# DGAC HF Voice/RTTY system—9114 Power Supply fails to initialise after a power failure

© 17-00194 Issue 1, January 1999

Figure 1: Wiring diagram for the AC contactor

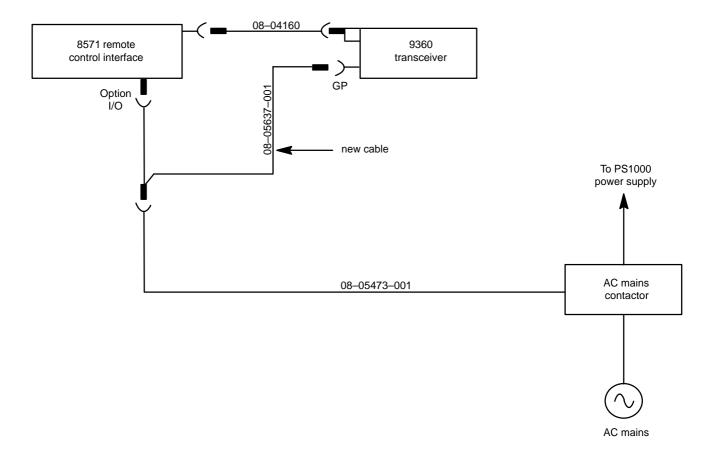
A problem occurs after an AC mains power failure. The Codan 9114 Power Supply fails to initialise due to the low impedance of the AC mains contactor on the 12 V DC power supply line. The problem is overcome by providing switched 12 V DC power from the General Purpose (GP) port of the transceiver instead of the I/O port of the 8571 Remote Control Interface.

Re—route the power supply line by connecting the cable provided (part number 08–05637–001) to the GP port of the transceiver (see Figure 1).

To re—route the power supply line from the GP port of the transceiver, a special purpose cable (part number 08–05637–001) must be connected (see Figure 1). The implementation is also shown in system drawing 03–00987 Issue C.

Six cables have been sent with this Service Bulletin. Three cables, (part number 08–05637–001) are provided for the new connection, and three cables, (part number 08–05473–001) are provided to replace the cables previously modified by the customer.
